Access Compliance Report

Public Rights-of-Way

(Curb Ramps)

Intersection ID: 10037850	Main Street: SHARON_RD	Cross Street: N/A	Location: NW
ADA ID: AC092A59BD18	Ramp Type: MedianPerp	Initial Pass/Fail: Fail	Overall Compliance: No
Severity Score: 10			
Codes/Mitigation Info/Possible Solution		Field Measurements/Component Compliance

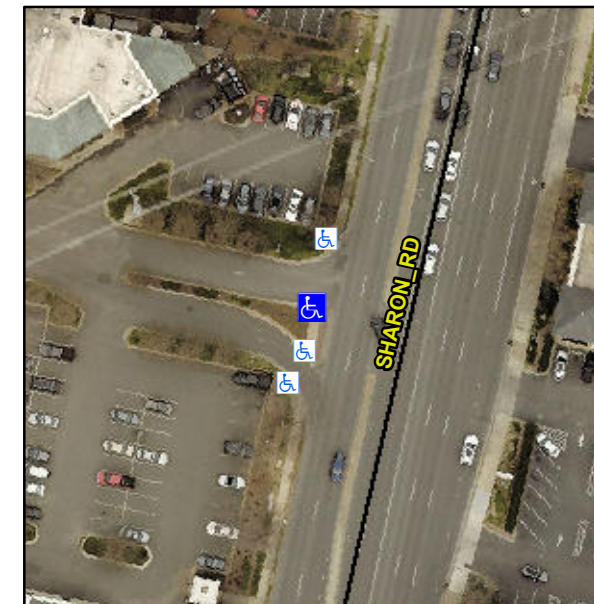
Not Found, R304.5.1, R304.5.3

Compliance	Description	Data	Compliance	Description	Data
N/A	Ramp Length (in)	58.0	Yes	Ramp Slope (%)	6.0
No	Ramp Width (in)	44.0	No	Ramp XSlope (%)	2.9
N/A	Flare Type LT	N/A	N/A	Flare Type RT	N/A
N/A	Flare Slope LT (%)	N/A	N/A	Flare Slope RT (%)	N/A
N/A	Flare Traversable LT?	N/A	N/A	Flare Traversable RT?	N/A
N/A	Landing Length (in)	N/A	N/A	DWS Provided?	N/A
N/A	Landing Width (in)	N/A	N/A	DWS Contrast?	N/A
N/A	Landing Slope (%)	N/A	N/A	DWS Length (in)	N/A
N/A	Landing X Slope (%)	N/A	N/A	DWS Full Width?	N/A
N/A	Landing Curb? (Y/N)	N/A	N/A	DWS Offset (in)	N/A
N/A	Shared Landing?	N/A			
N/A	Gutter Ponding?	N/A	N/A	Gutter Slope (%)	N/A
N/A	Gutter Lip Ht (in)	N/A	N/A	Gutter X Slope (%)	N/A
N/A	Painted X Walk1?	No	N/A	Painted X Walk2?	N/A
	X Walk 1 Direction	To N		X Walk 2 Direction	N/A
N/A	X Walk 1 Width (in)	N/A	N/A	X Walk 2 Width (in)	N/A
	X Walk 1 Slope (%)	0.7		X Walk 2 Slope (%)	N/A
	X Walk 1 X Slope (%)	1.5		X Walk 2 X Slope (%)	N/A

Remove & Replace Entire Ramp.
